SUBJECT: Veterans Airport of Southern Illinois
Marion, Illinois
Williamson County
Illinois Project Number: MWA-4829
AIP Project Number: 3-17-0065-XXXX
Contract No. WI058
Item No. 03A, July 31, 2020 Letting
Addendum A

NOTICE TO PROSPECTIVE BIDDERS

Reason for Addendum:
Construction Plan Clarification

To All Plan Holders:
Replace Sheet 6 with revised Sheet 6 revision date 7/09/2020

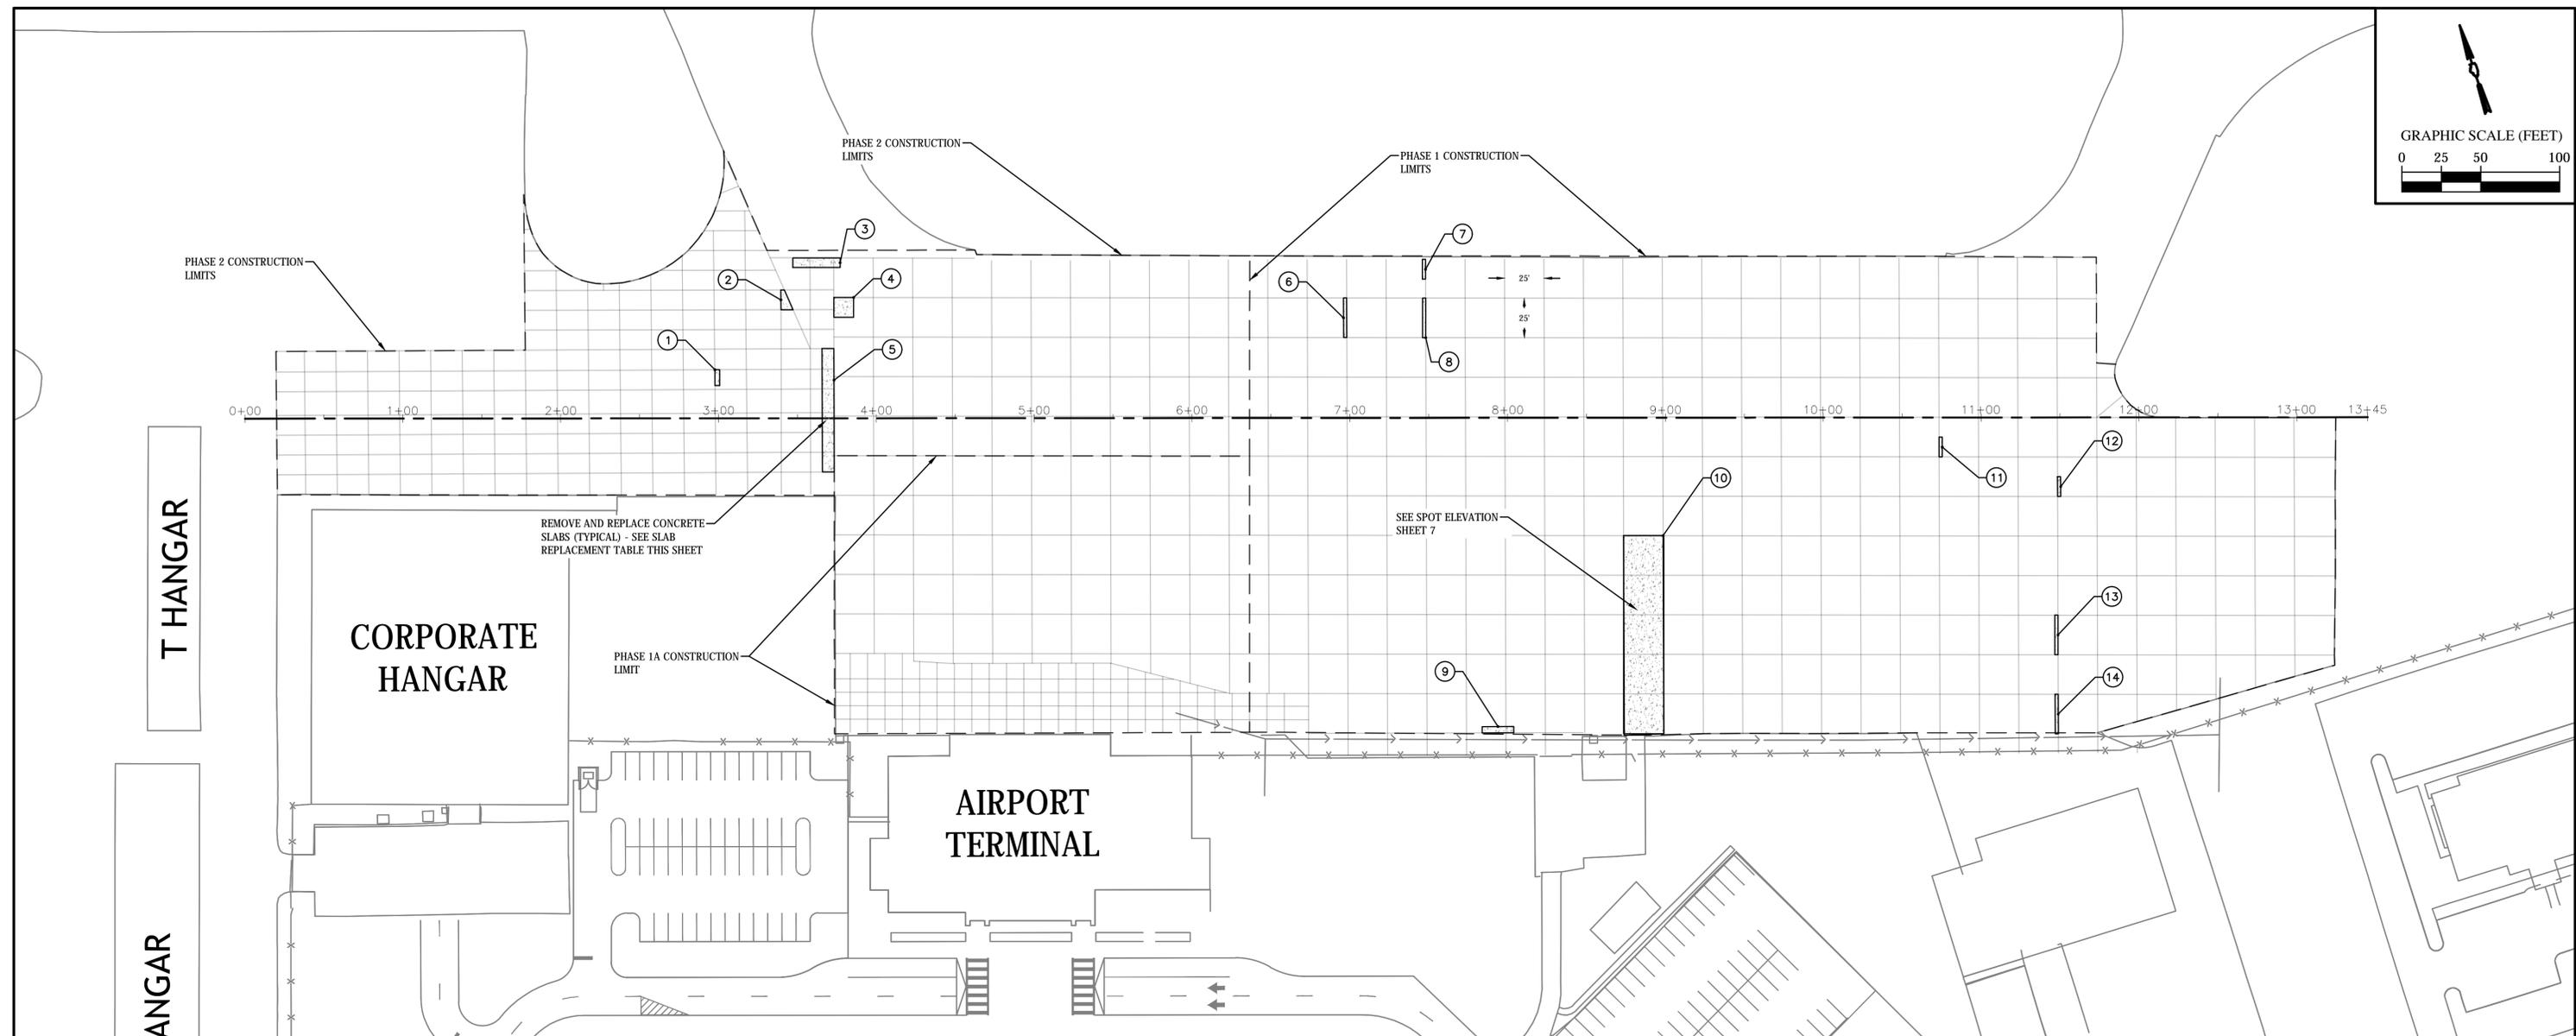
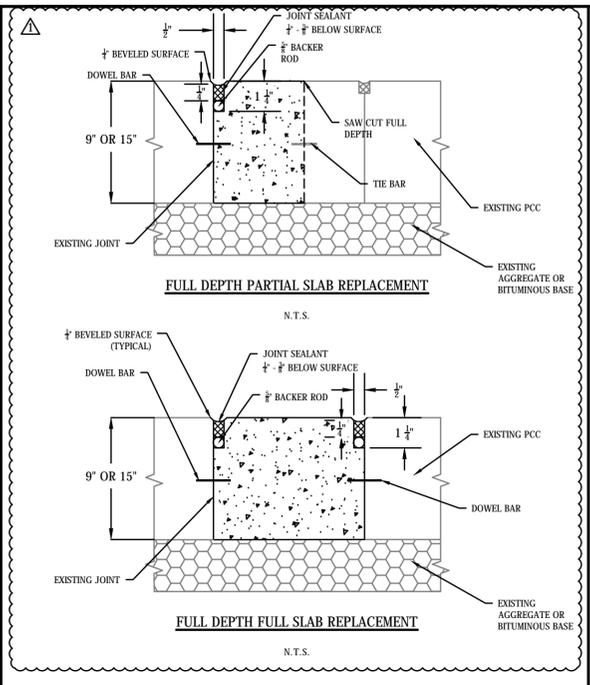
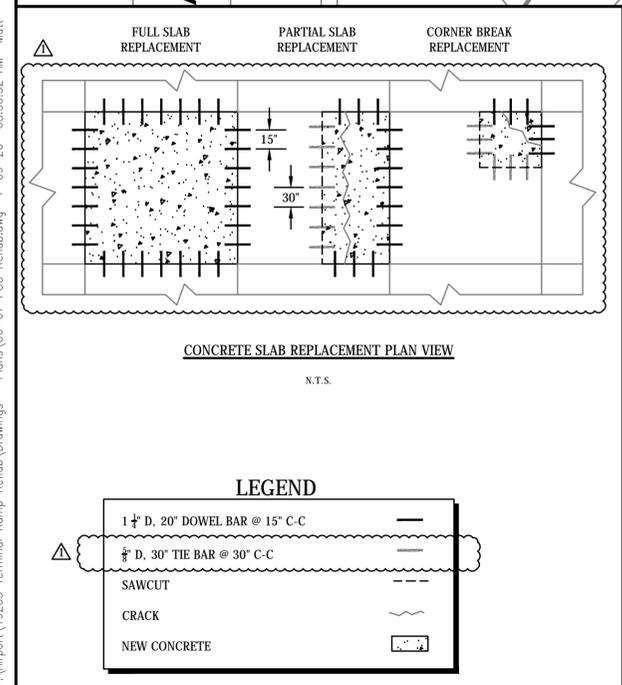
- Concrete Slab Replacement Plan View – Dimensions changed, Dowel Bar shown on Partial Slab Replacement
- Slab Replacement Details – Joint Dimensions added
- Legend – Tie Bar Length added
- Spall Repair Notes – Deleted (See Sheet 8 for spall repair notes)
- Detailed Notes – Added note number 9
